06V-377

DEFECT INFORMATION REPORT: AMG-R0601

DEALER NOTIFICATION LETTER
SAFETY RECALL AMG R0601
STEERING GEAR ATTACHMENT

Subject: PRODUCT RECALL AMG R0601 STEERING GEAR ATTACHMENT

Figure 1: Steering Gear Attachment Hardware

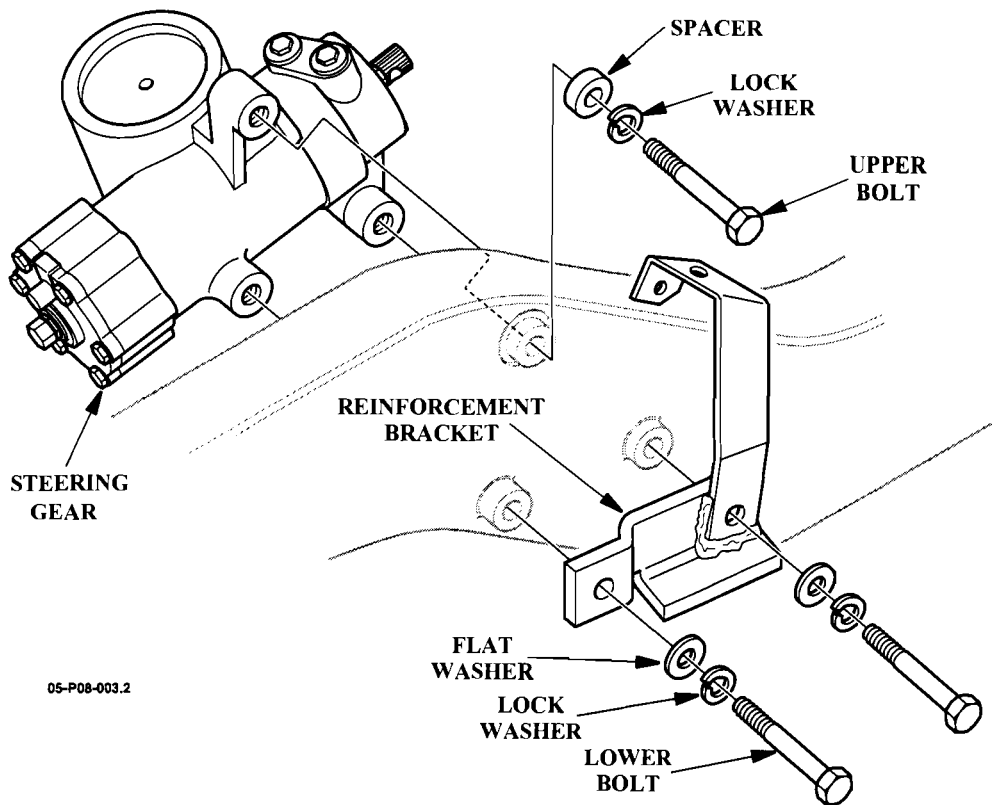
1. Perform a visual inspection of the hardware attaching the steering gear to the frame. The **upper bolt** requires a spacer and a split lock washer (See Figure 1). Both **lower bolts** use only a flat washer and a split lock washer.
2. If the spacer and washers are in the correct positions, apply 175 lb-ft. (237 N·m) of torque to all three bolts.
3. If any of the bolts rotate before the torque value is attained, remove all the bolts and clean all thread locking compound from the gear and the bolts.
4. Apply Loctite 242, or equivalent medium strength thread locker to the threads, place the spacer and washers on the bolts in the positions shown below and torque the bolts to 175 lb-ft. (237 N·m).

1. If the spacer and washers are not in the correct positions, replace the steering gear and hardware (See Service Manual Section 8). Torque the bolts to 175 lb-ft (237 N·m).
